All Storage @Chuyenne & Fort Apache

CITY OF LAS VEGAS		DATE:
INTER-OFFICE MEMORANDUM		April 25, 2018
TO: Land Development Services Department of Building & Safety		FROM: Albert Sung, P.E. Flood Control Project Engineer Department of Public Works
SUBJECT:	Drainage Study for:	
	All Storage @ Cheyenne & Fort Apache	
Cross Streets:	NWC of Cheyenne Blvd. & Dapple Grey Av.	
File Number:	F:\Depot\DSMemos\DS4976A.doc	
Parcel Number:	138-08-401-013	
Zoning Action:	SDR-71559	
FEMA Flood Zone	YES	NO X
Proposed Storm Drain	YES	NO X
		COPIES TO: Horrocks Engineers Cheyenne Investors, LLC Bart Anderson, P.E., DevCo

TECHNICAL DRAINAGE STUDY FOR
ALL STORAGE
@
CHEYENNE AND FORT APACHE
(APN 138-08-401-013)
IN
THE CITY OF LAS VEGAS, CLARK COUNTY, NEVADA

EXISTING CONDITIONS BASIN MAP

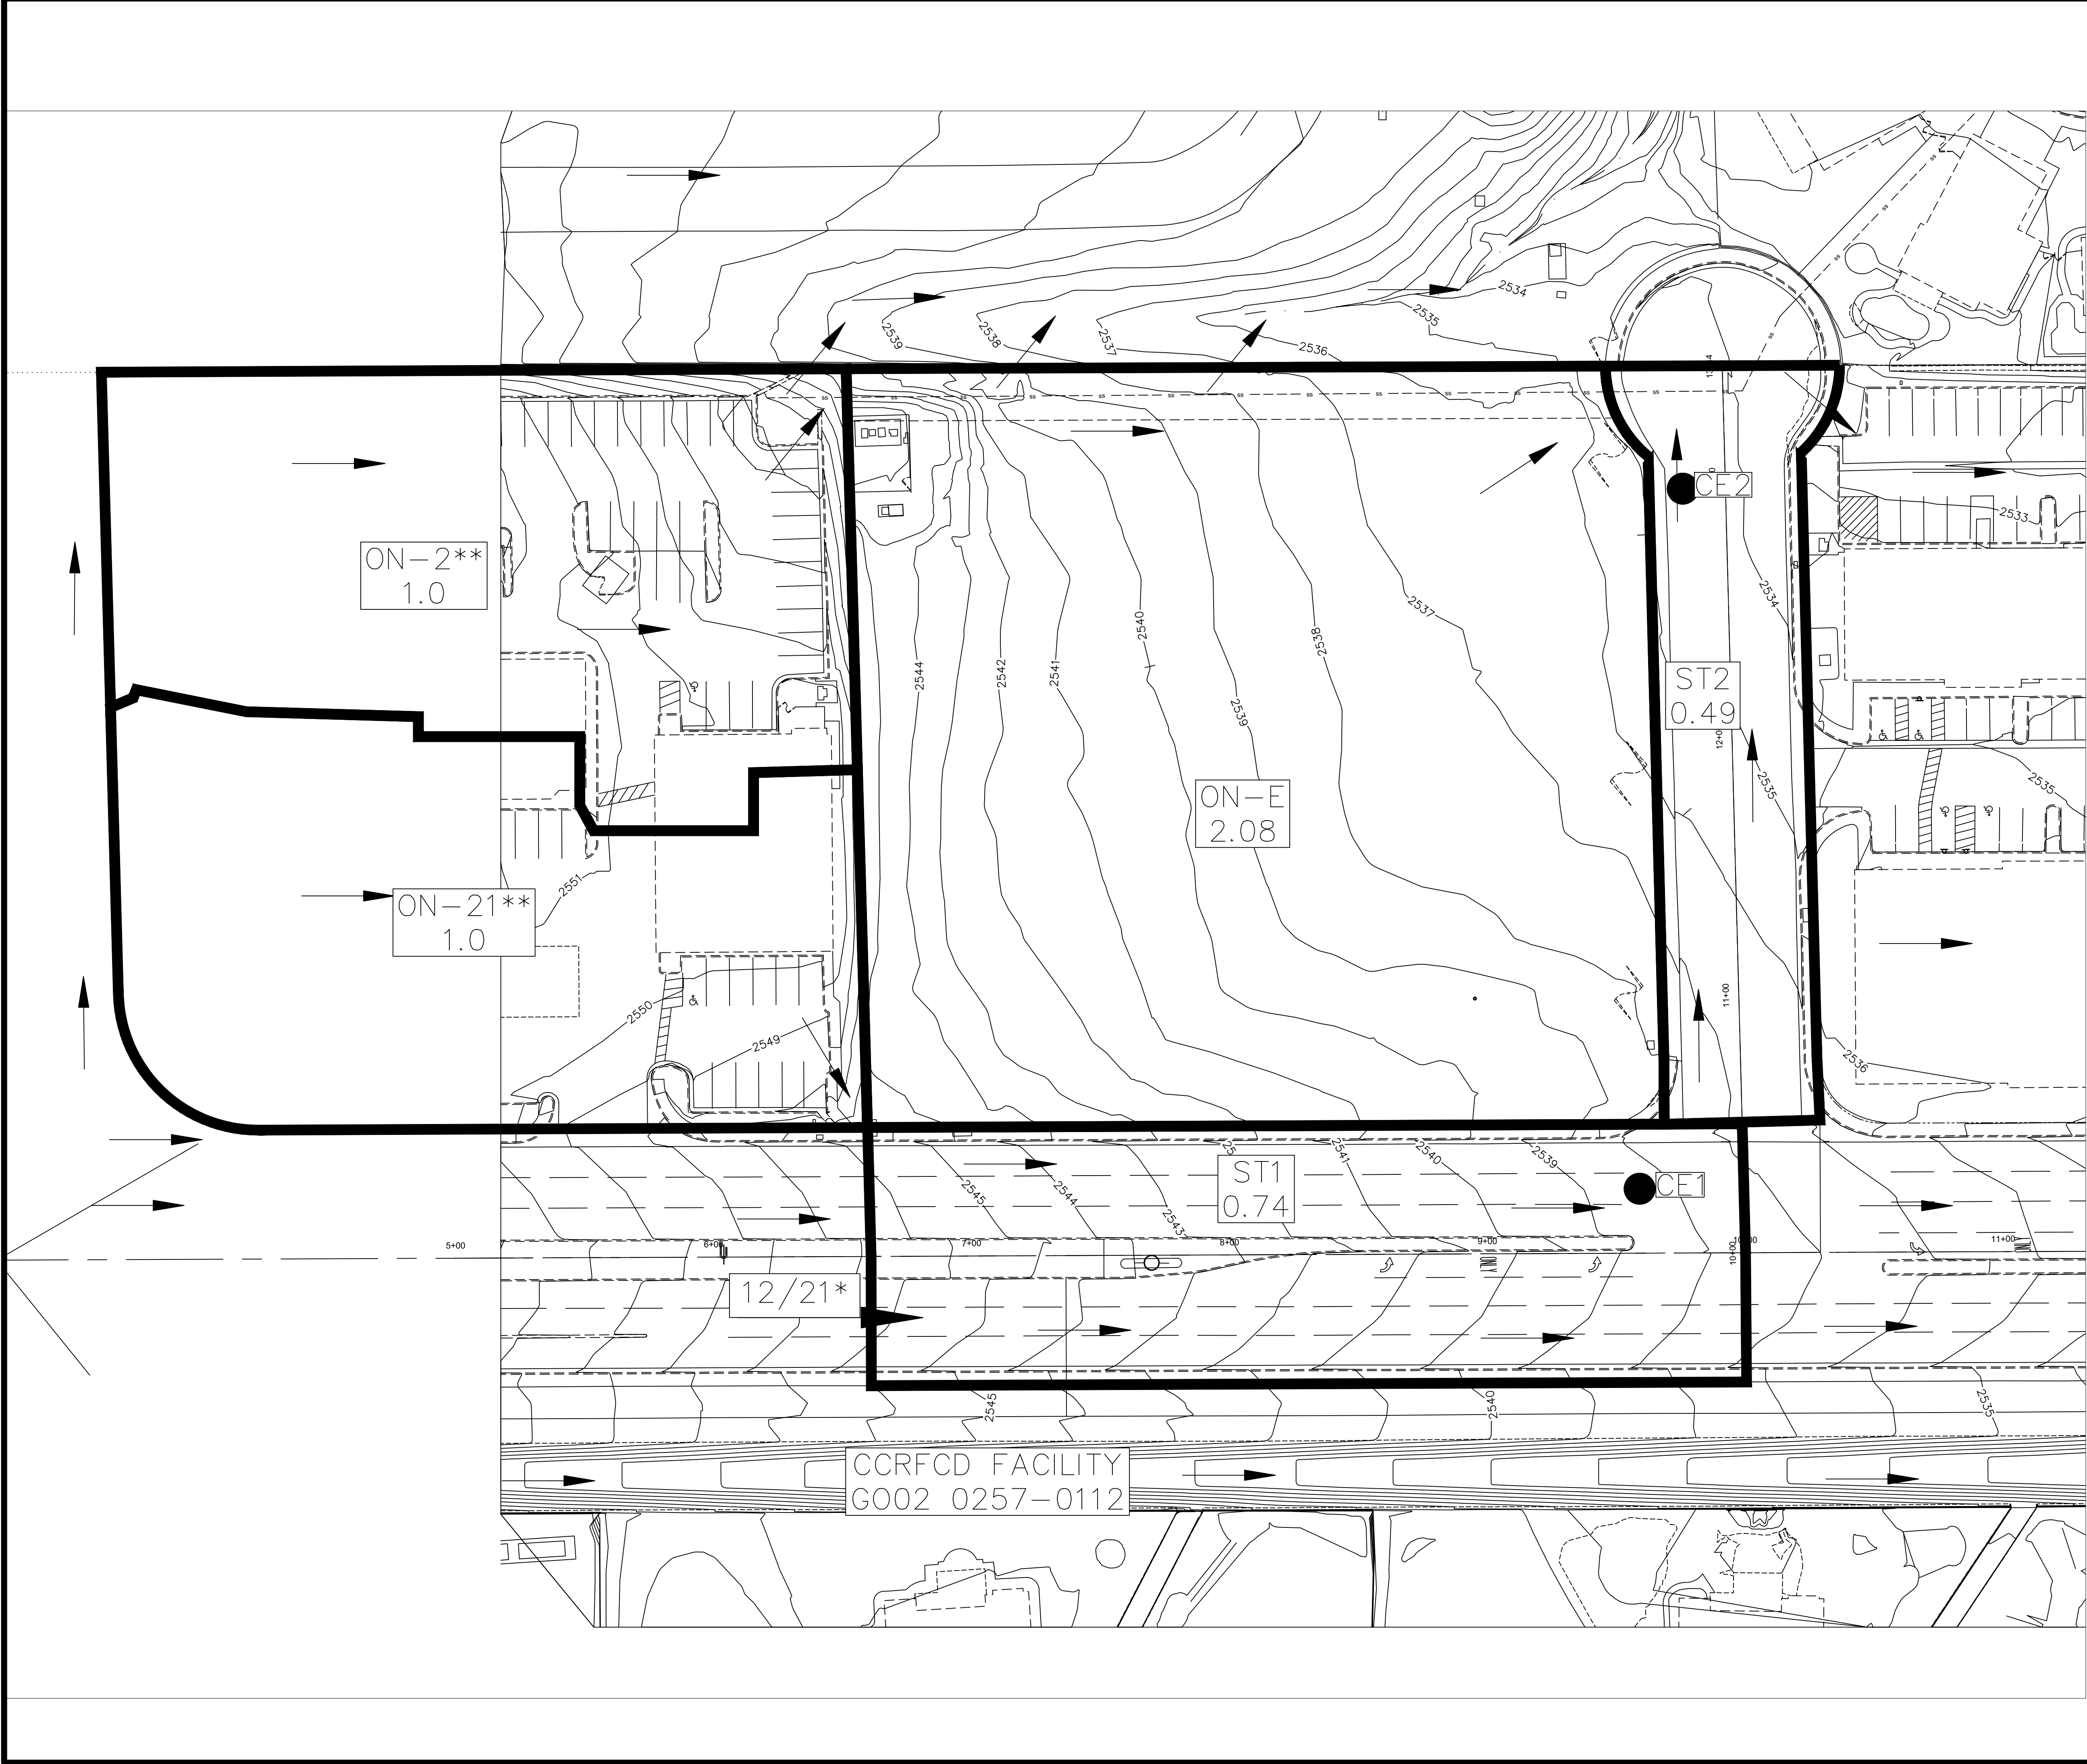
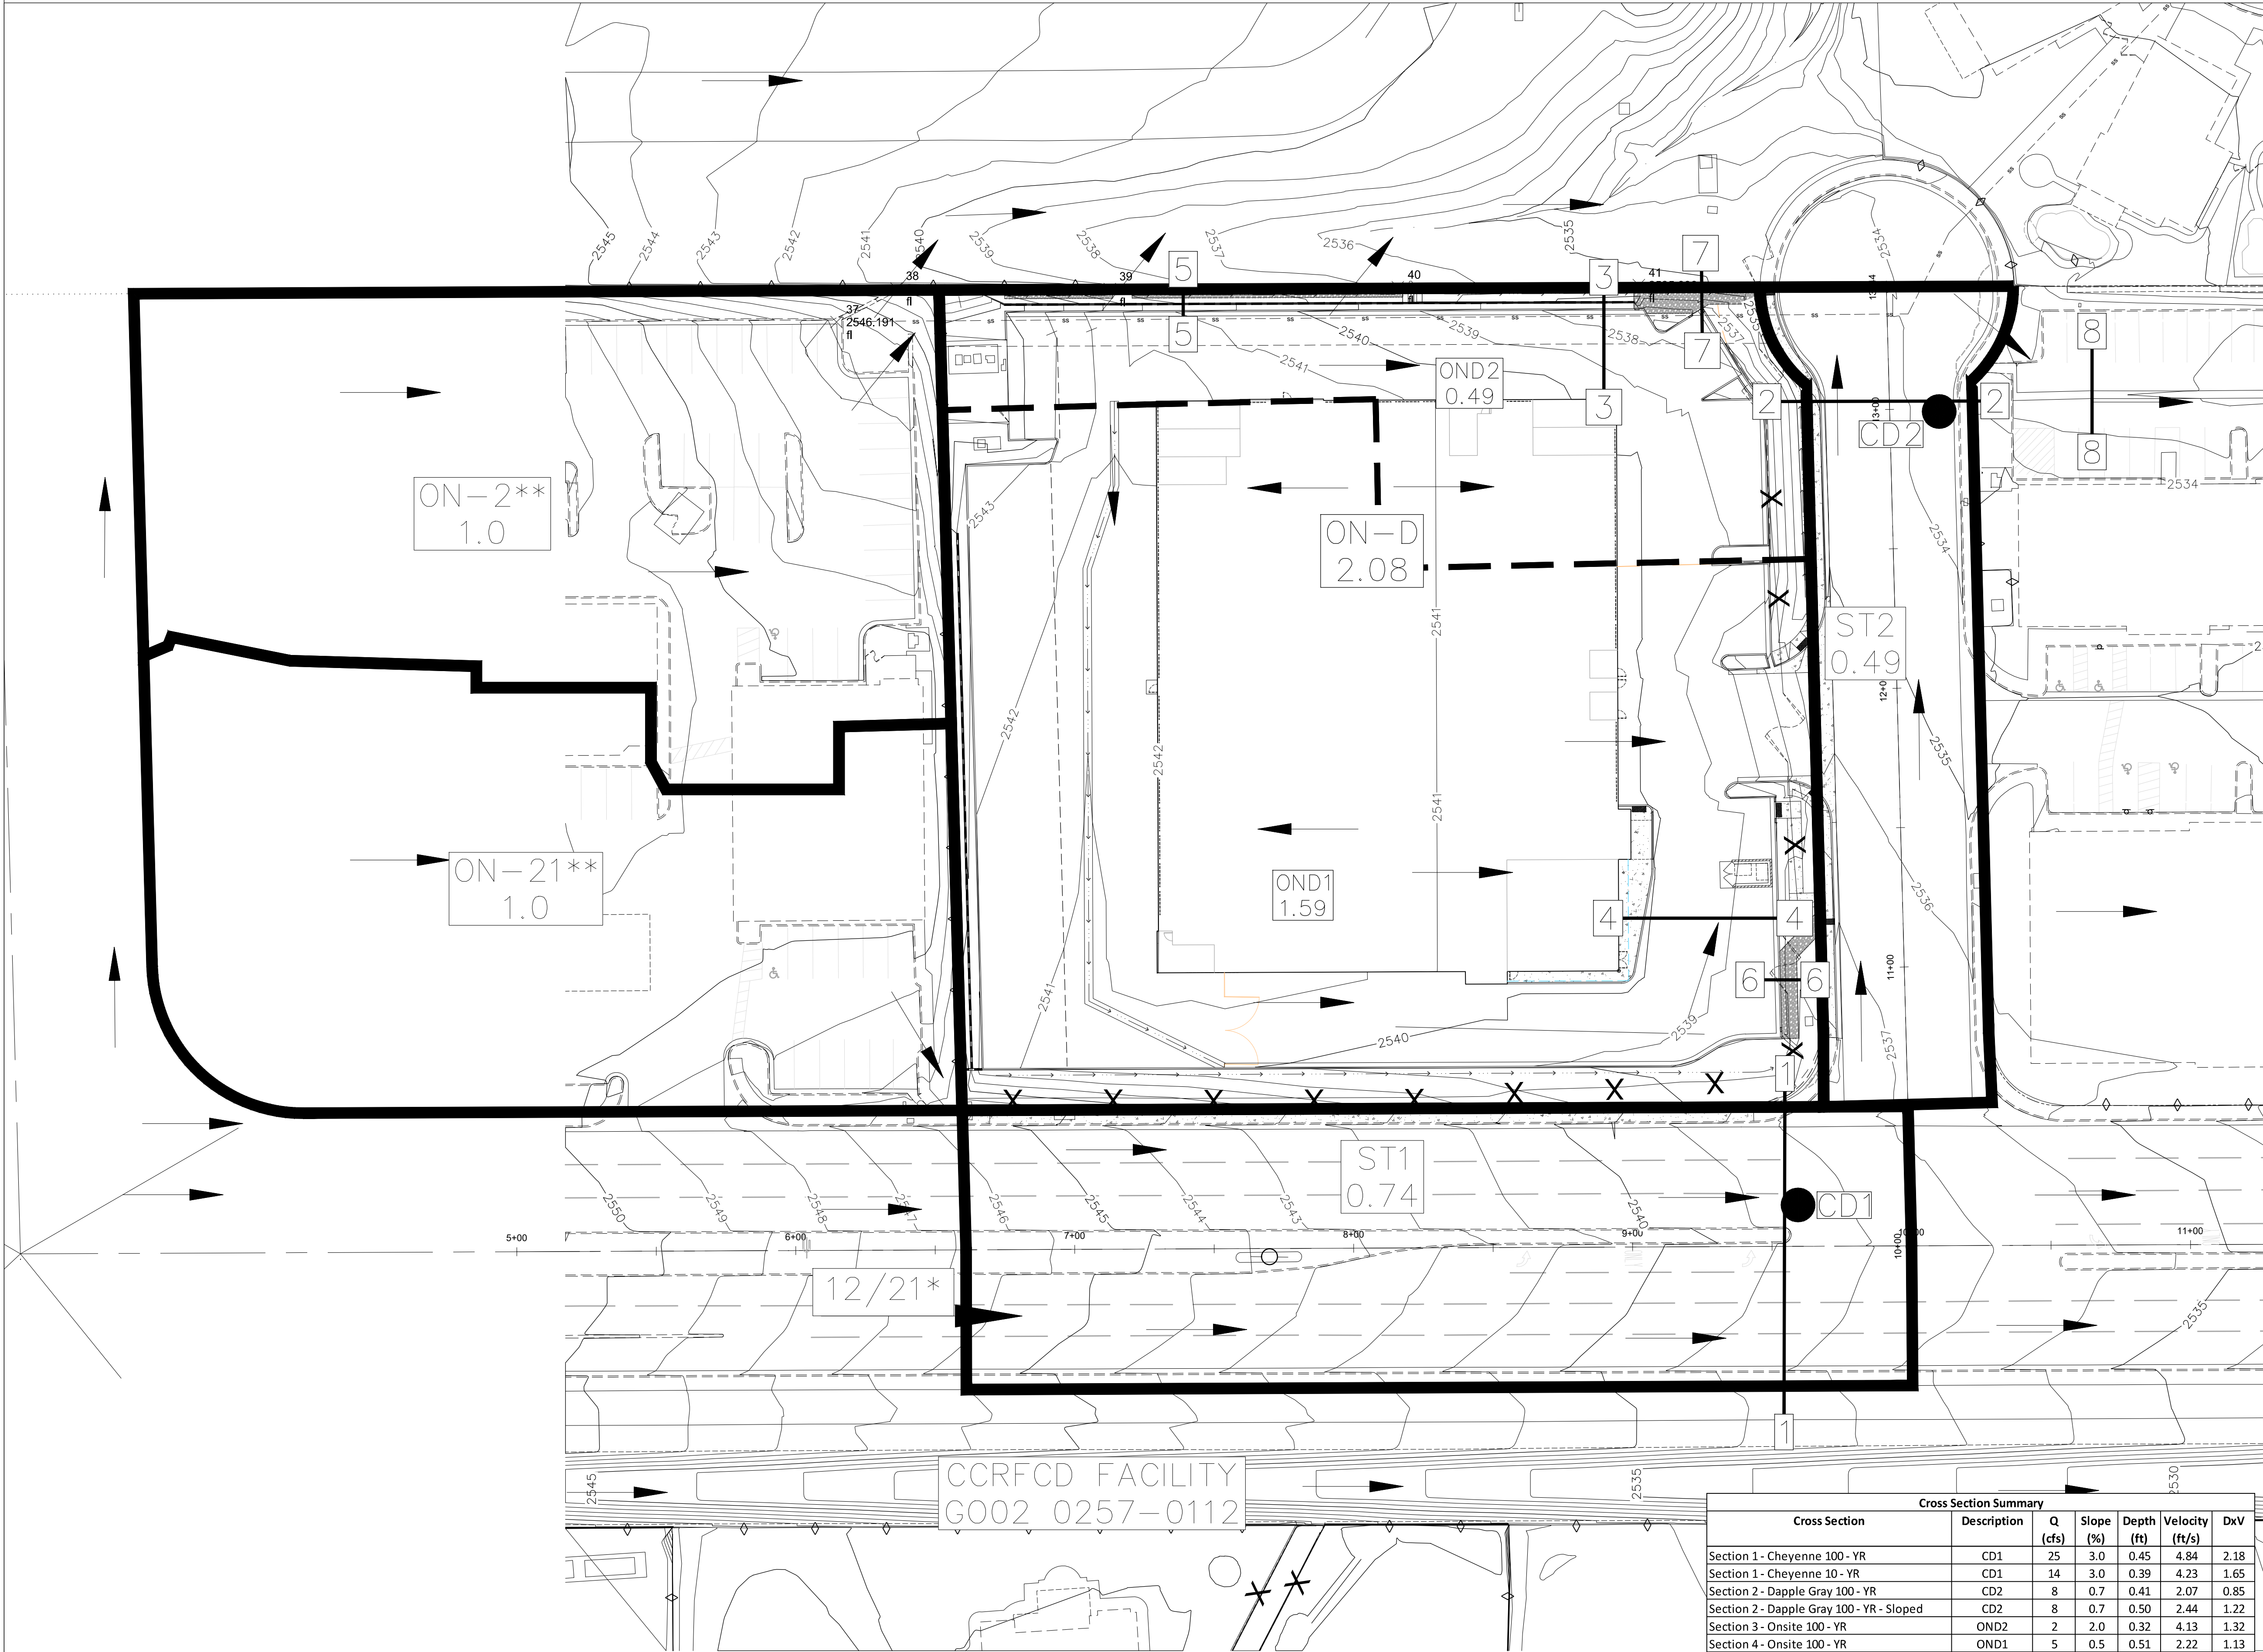
5. Label an existing drainage easement in the property on the east side of *Dapple Grey Avenue* with recorded document number on the grading plan.
6. Label the street names of the perimeter roadways in both of the Existing and Developed Conditions Basin Maps.

GRADING PLAN
138-08-401-013

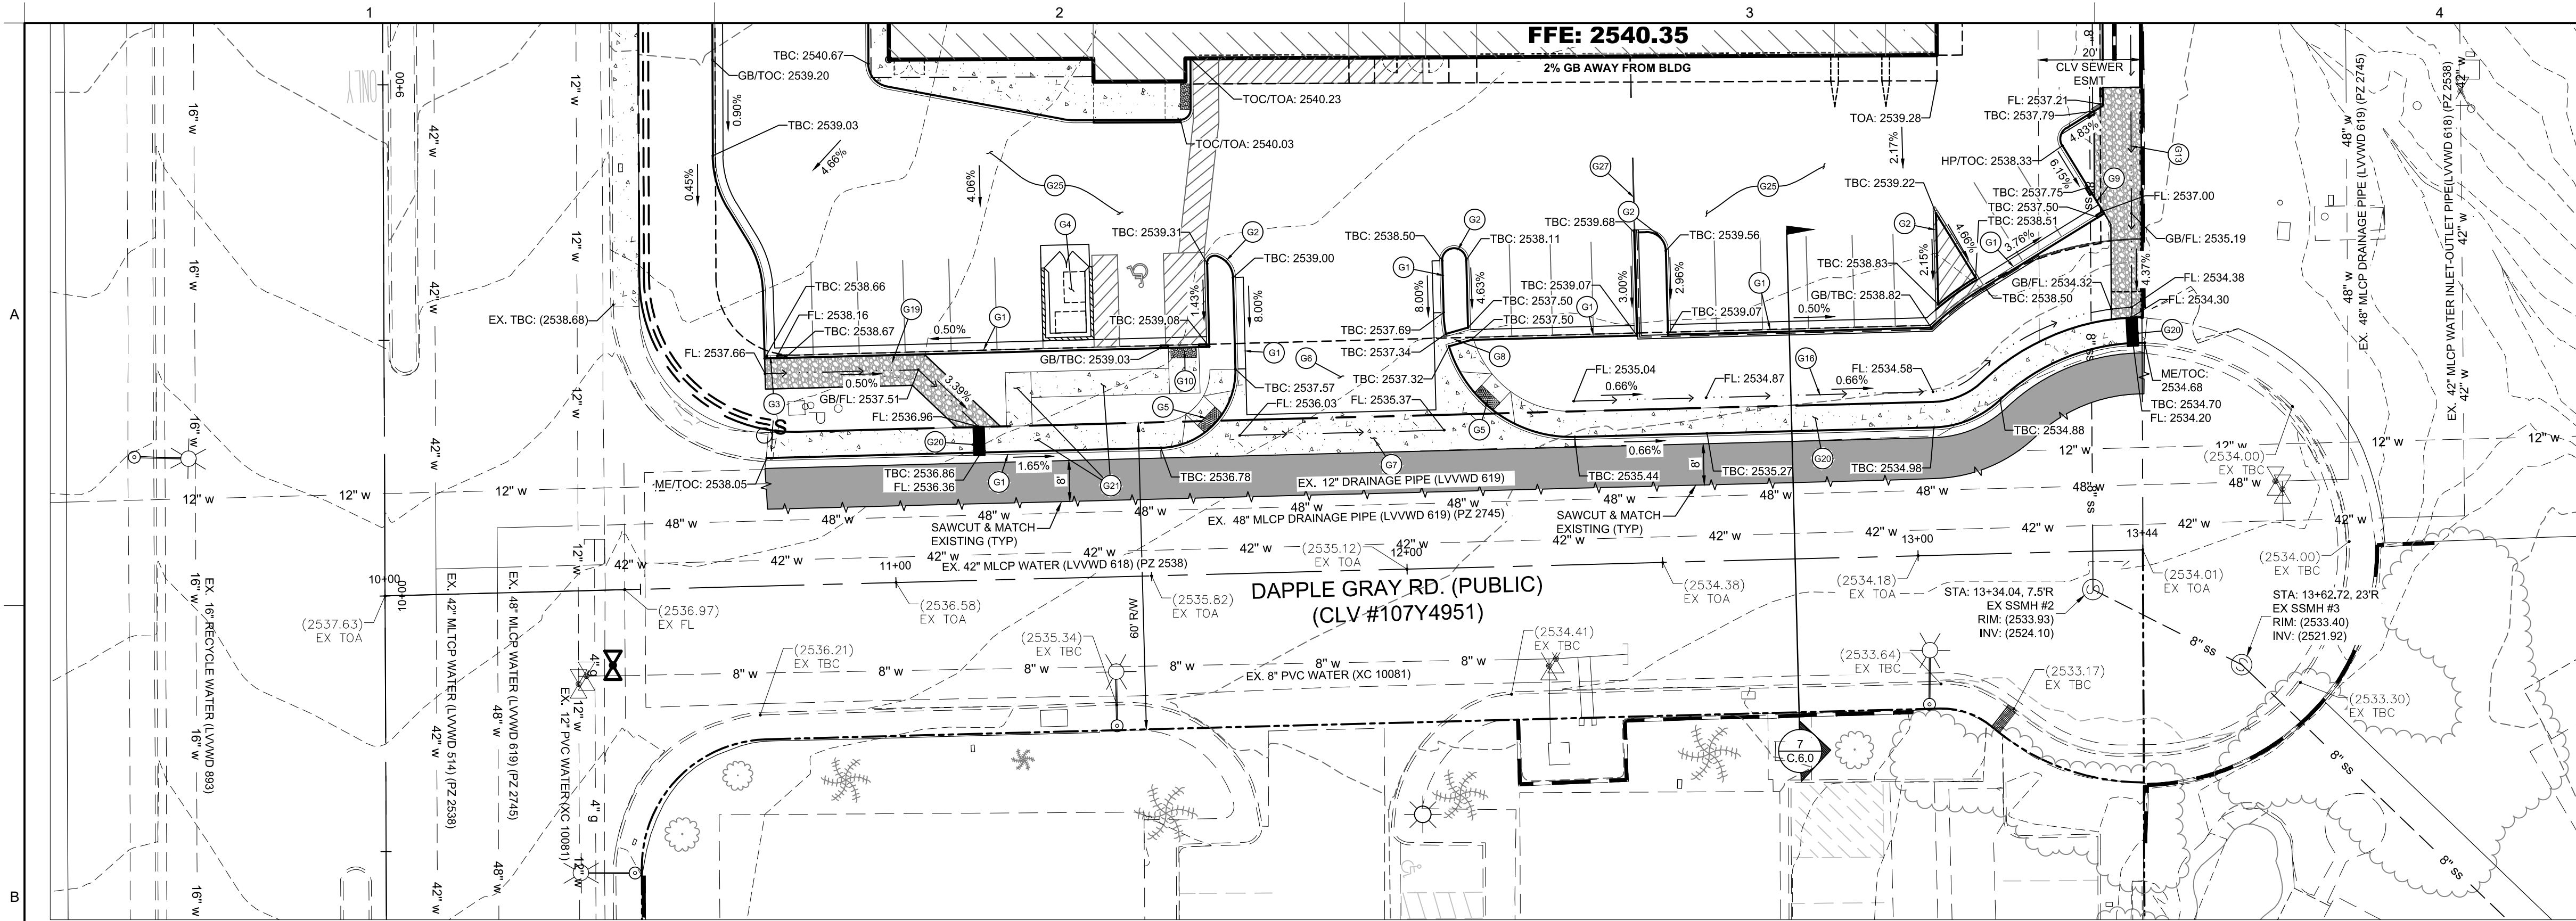
2. The subject development accepts flows from the adjacent property through the northwest corner. Provide public drainage easement along the northern boundary of the site to perpetuate offsite flows. Public drainage easement must be recorded by separate document prior to the final acceptance of the improvement plans unless they are recorded by parcel map or final map.

3. The required public drainage easement must be 10'-wide minimum and is to be privately maintained. Clearly label as such in the grading plan and the recording documents. Concrete lined the easement so as to ease the burden of future maintenance by the property owner.
